Development Review Committee

Re: <u>Trailside Townhomes – Site Plan and Plat Amendment Request</u>

Application No.:	SPR-58-2022 and SUBD-111-2022
Applicant:	John Wheatley, representing IKON Development
Project Location:	2142 East Brookings Dr.
Current Zoning:	RR-22 (Rural Residential), RR-43 (Rural Residential), and RM (Multi-
	family) Zone
Acreage:	19.37 Acres (Approximately 843,757 ft ²)
Request:	Request for approval of a Site Plan and Plat Amendment in the
	RR-22 and RR-43 zones in order to develop the vacant property
	with 152 townhomes.

EXHIBIT F SITE PLAN

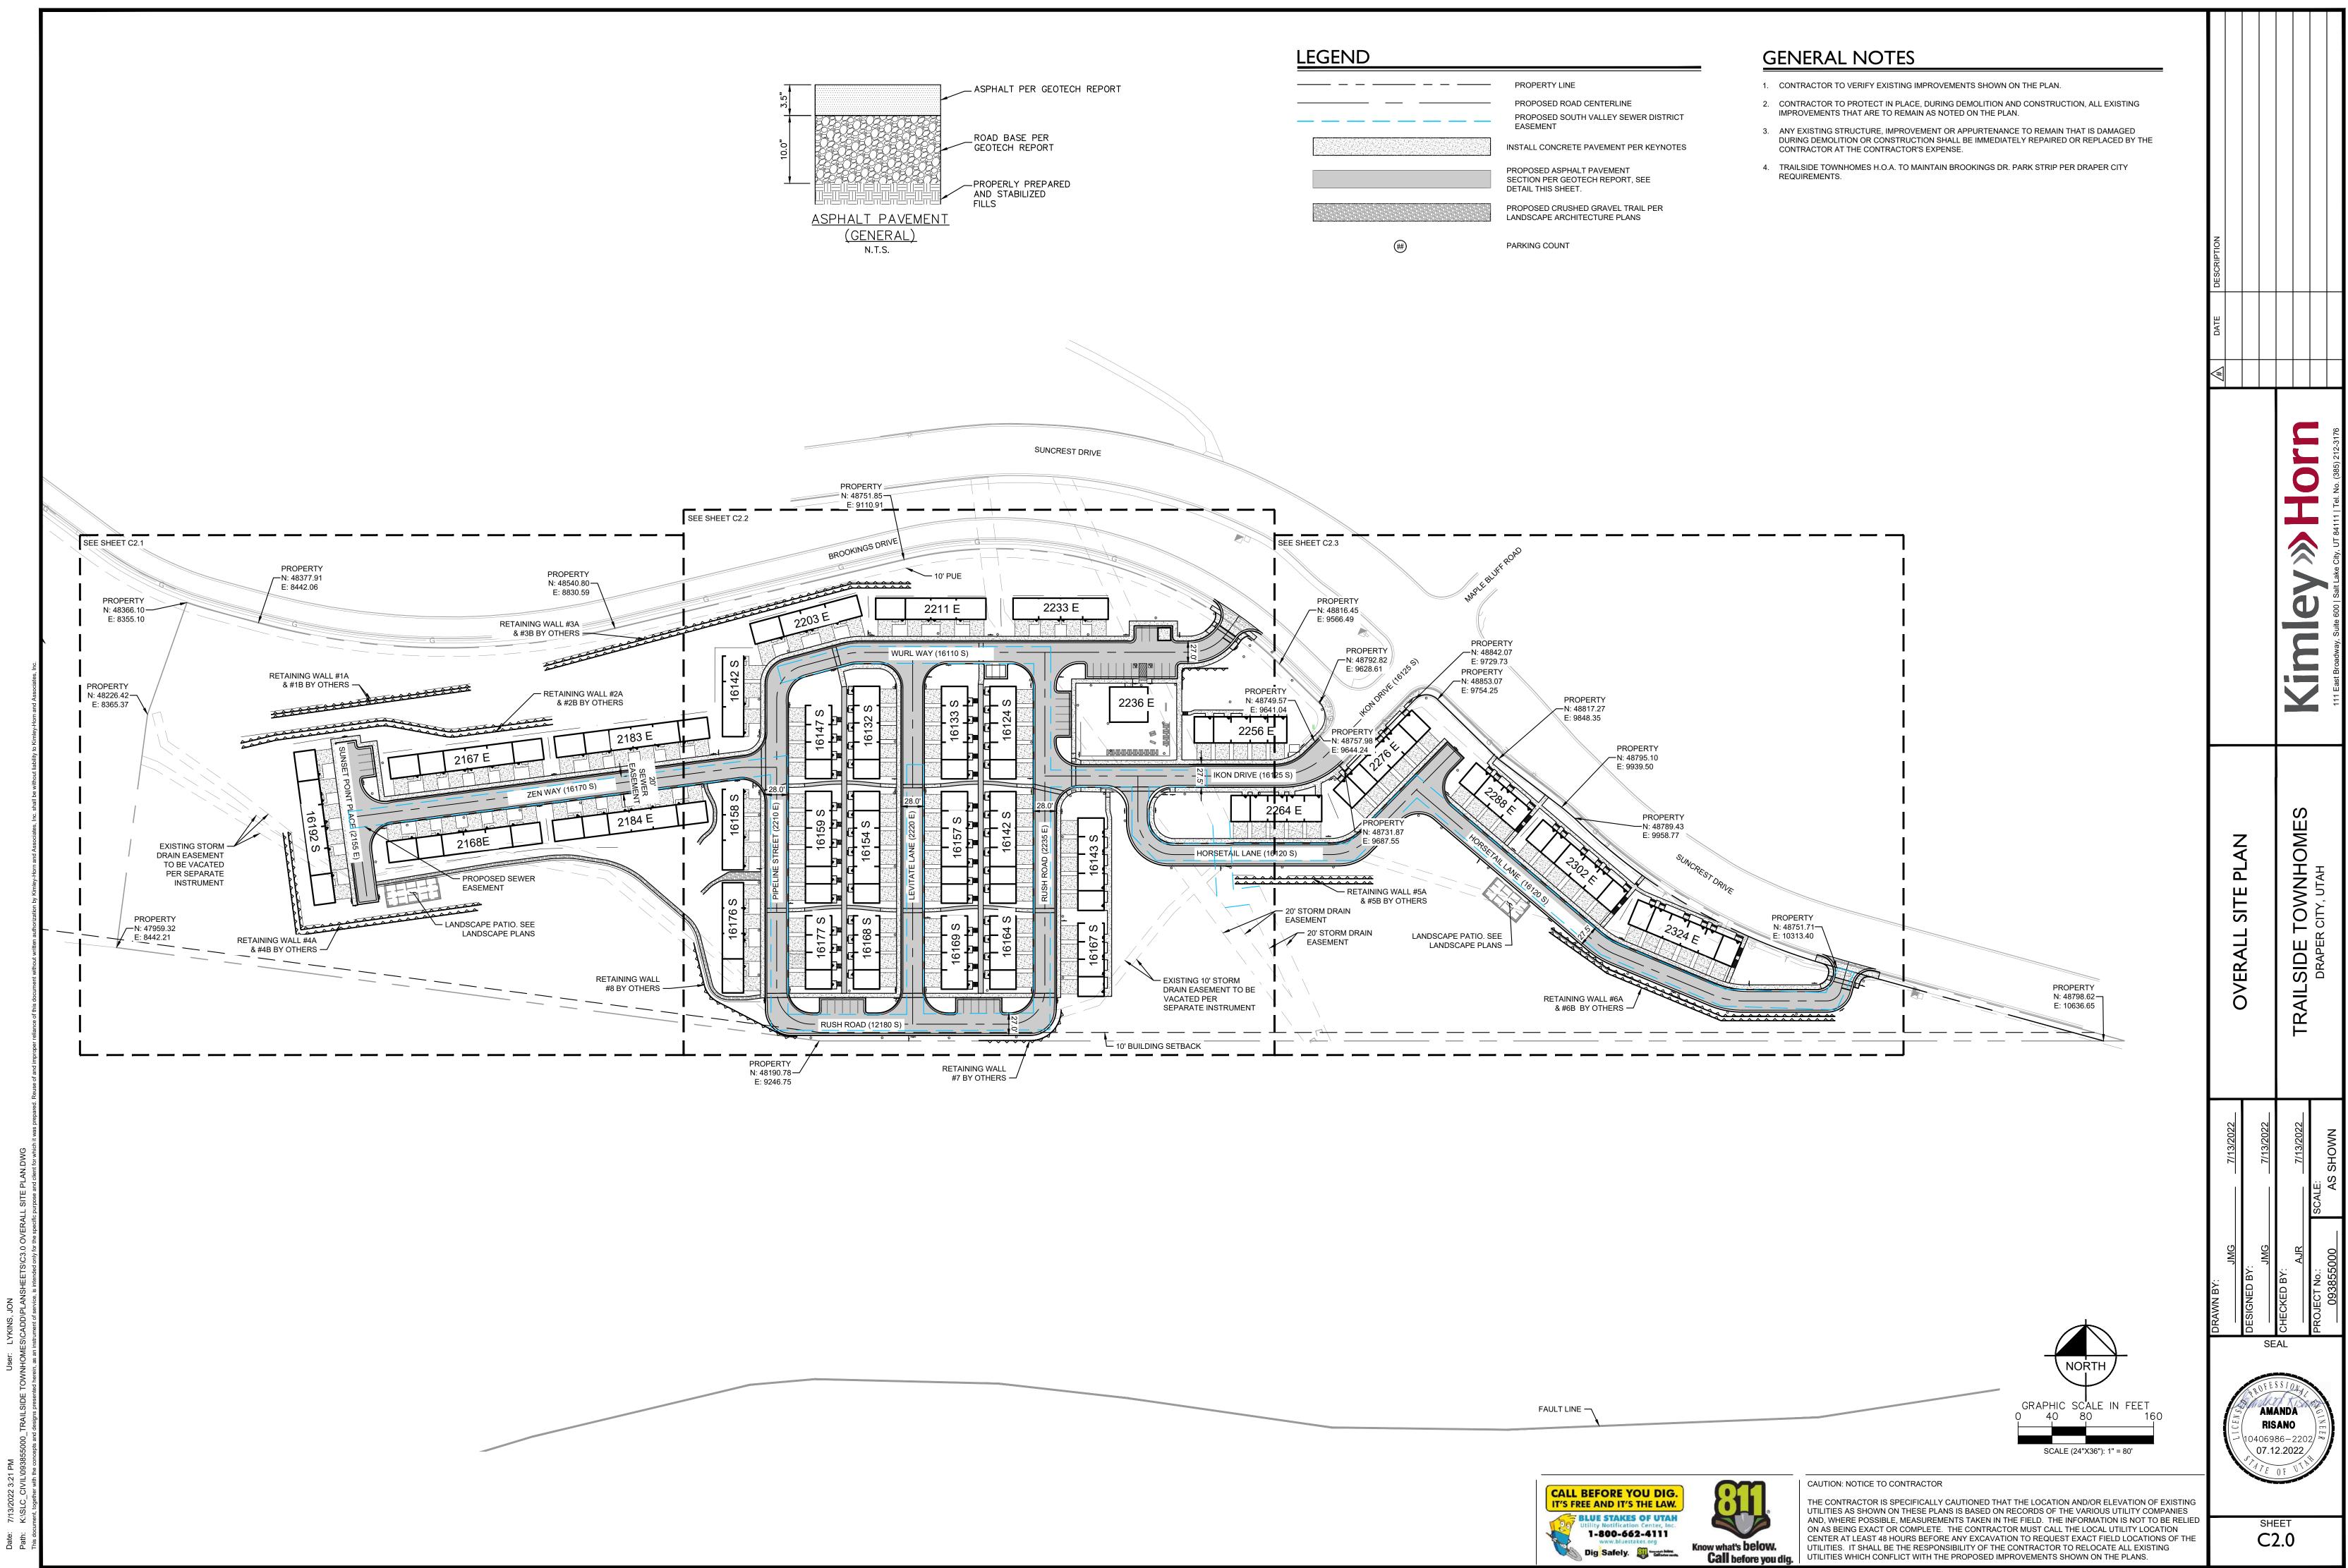
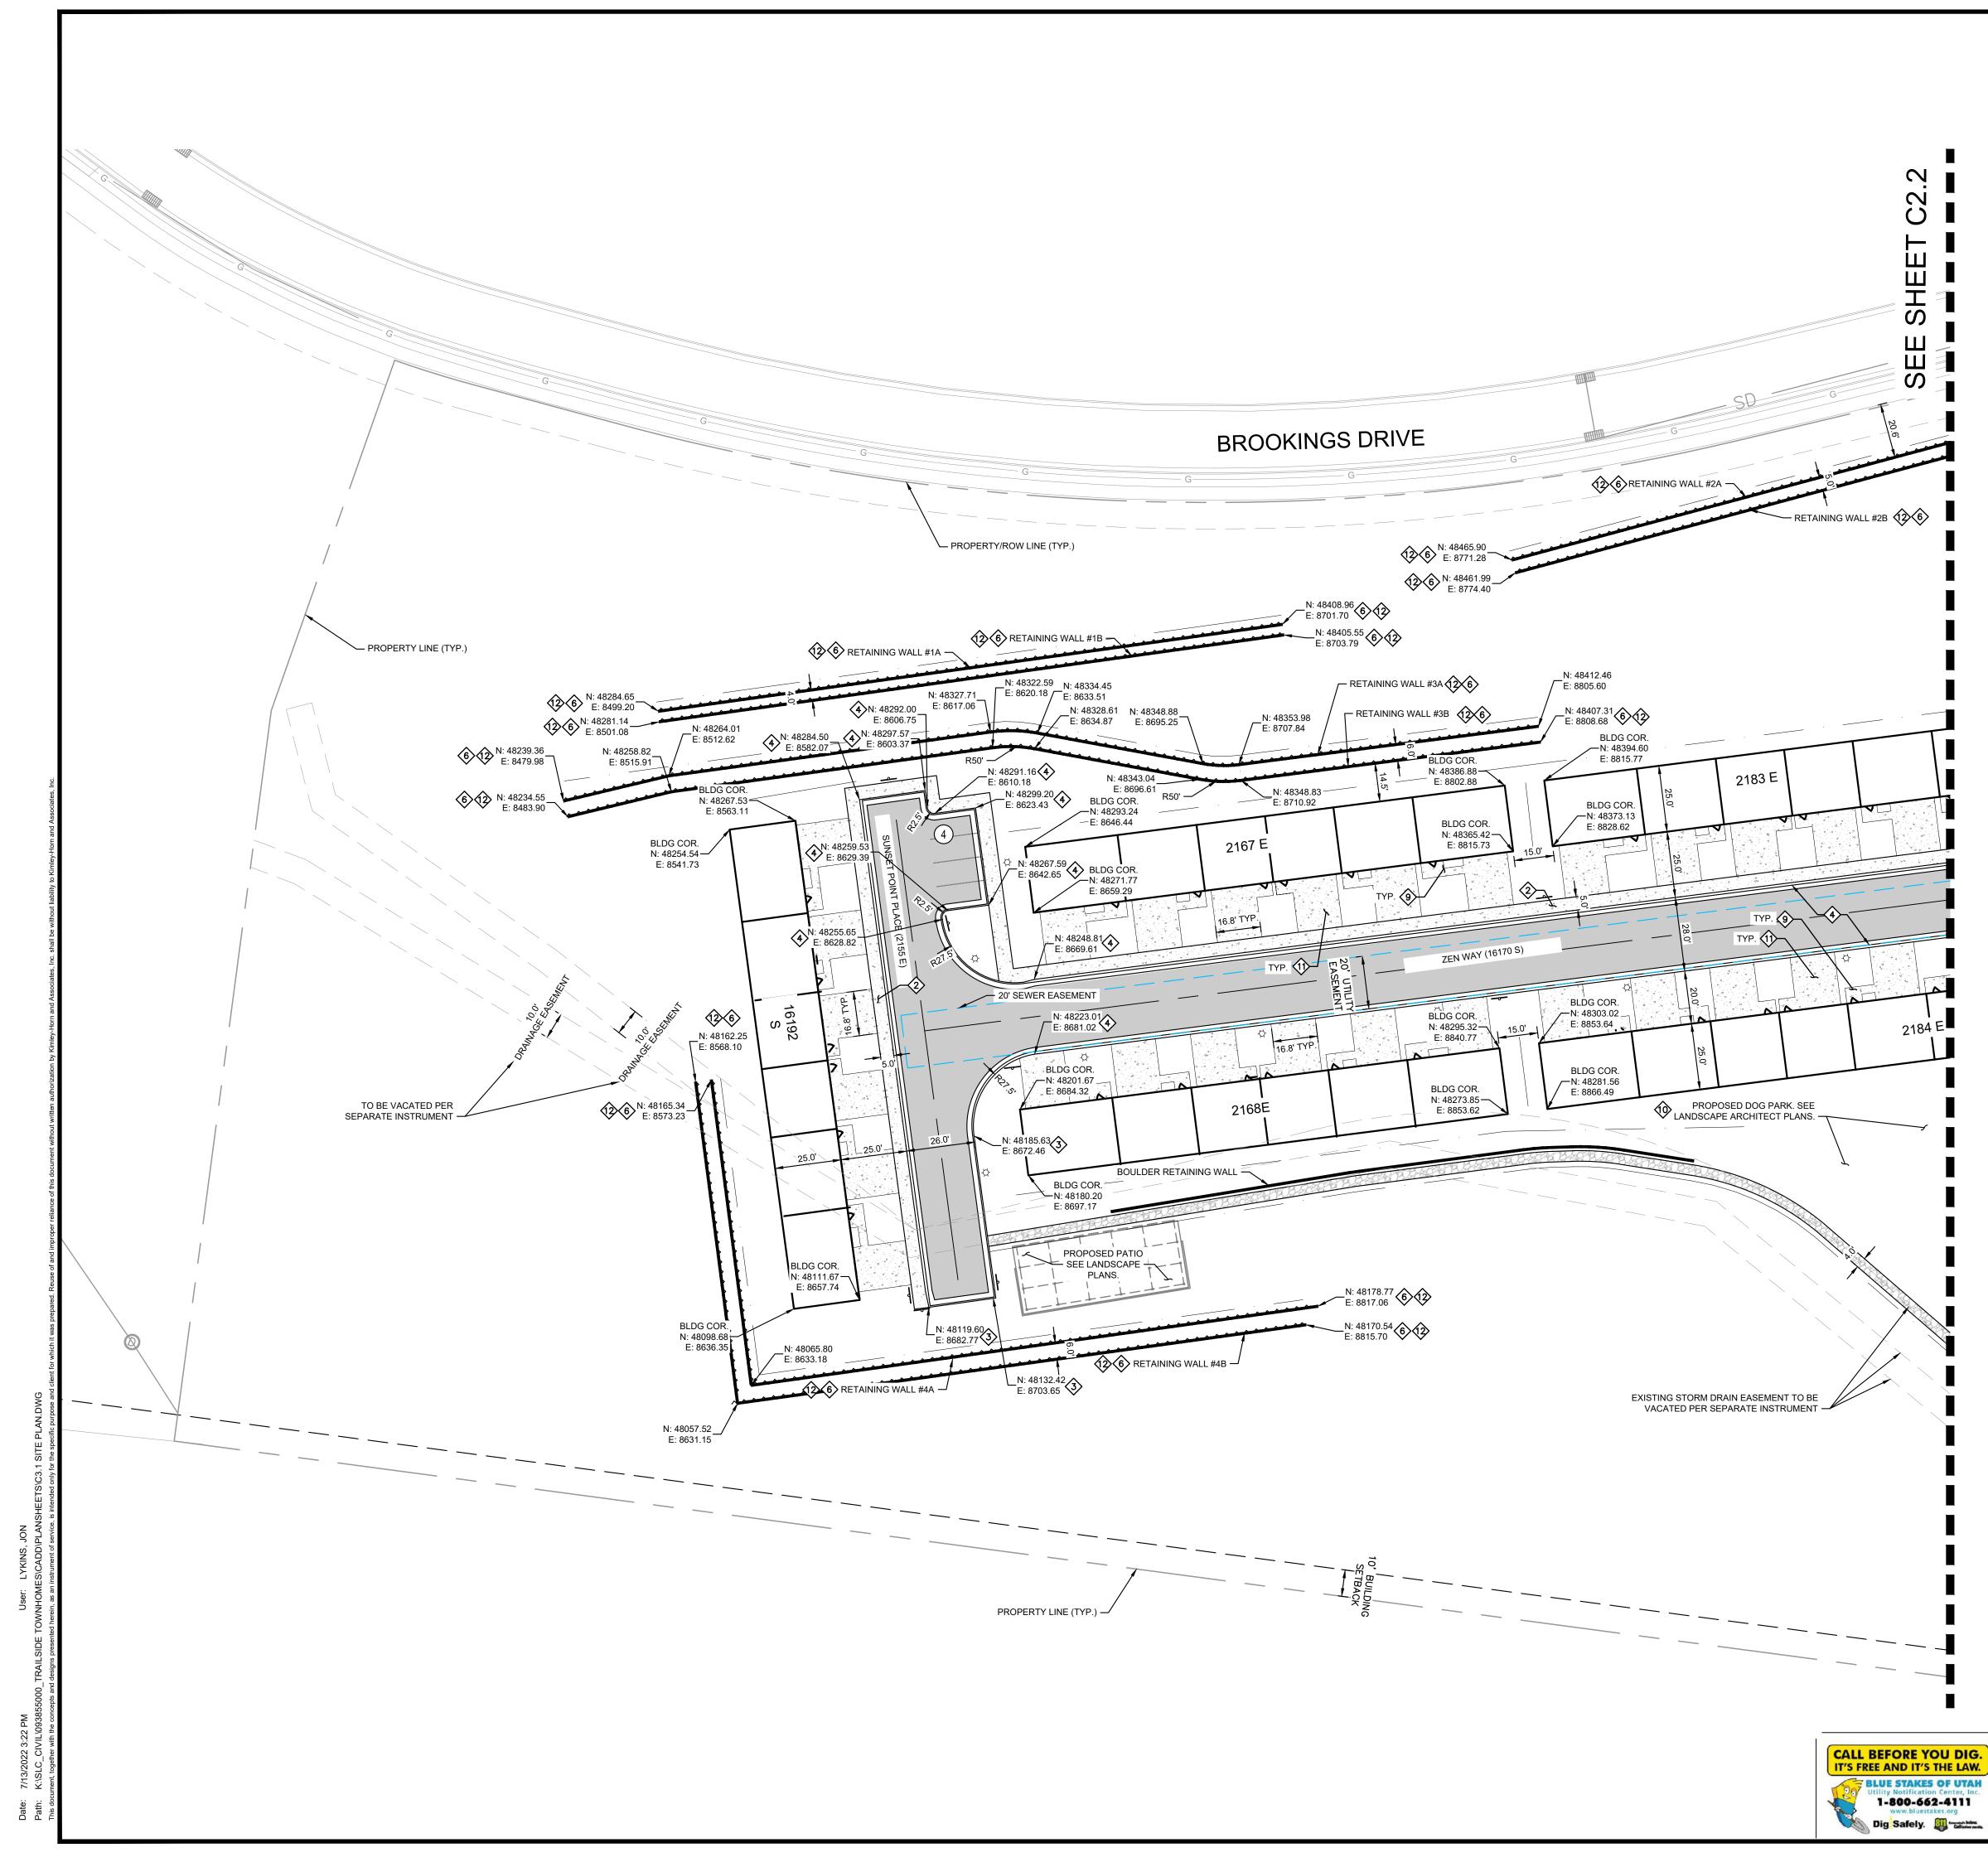
Site Plan Layout. The property will be developed with 32 townhome buildings equaling 152 dwelling units (Exhibit F). The site will be accessed from Brookings Dr. and Suncrest Dr. There will three ingress and egress points in total.

Boundary Line Setback-			
Front	Min 5-feet to Max 20- feet	10-feet	
Front	Min 5-feet to Max 20- feet	17-feet	
Rear	10-feet Min	61-feet	
Rear	10-feet Min	178-feet	
Driveway Depth	20-feet Min	19-feet	Changes required

<u>Circulation</u>. The applicant is proposing private roads (Exhibit J). Dwelling units will be a mix of alley loaded and front loaded structures depending on their location in relation to areas with large ground slopes. The center of the development will have a grid system with alley loaded units and a center walkway running between the front of the units. A western single road spur will serve front loaded units on either side of the street. Two eastern spurs will serve units on one side of the road. These units will be alley loaded.

Stub Street Connections	Required to connect to all stub streets	The property will have direct connection to the Brookings Dr. stub	There is not a requirement to continue the public roadway through the property.
# of Cul-de-sacs	NA	1	
Street Width	26-feet Min	26-feet to 28-feet	
Street Ownership	Private		
Sidewalks	Sidewalks required on both sides of the street	Sidewalks on one side of the street	Deviation requested

The applicant has submitted a request outlining how they believe they have complied with the deviation standards (Exhibit K). The applicant states that the development will have a mountain ambiance and use reduced hardscapes and narrower rights-of-way similar to what is seen in the nearby Suncrest development. The applicant also discussed the restriction on usable space for the development based on the grading and slopes on the property. Staff has reviewed the sidewalk design. There are two buildings that won't have a sidewalk running in front of them. They will have access to pedestrian trails at the ends of the roadway. All other units have ample pedestrian access.

<u>*Parking*</u>. The applicant is providing two car garages for each unit, along with a two car driveway (Exhibit F). Guest parking is provided around the club house area and on the west side of the development.

- A. Show driveway dimensions for all buildings.
 - B. All driveway shall be at least 20-feet deep, not including the sidewalk.
- 4. Prior to Land Disturbance Permit issuance, amend the architectural plans to address all outstanding comments:
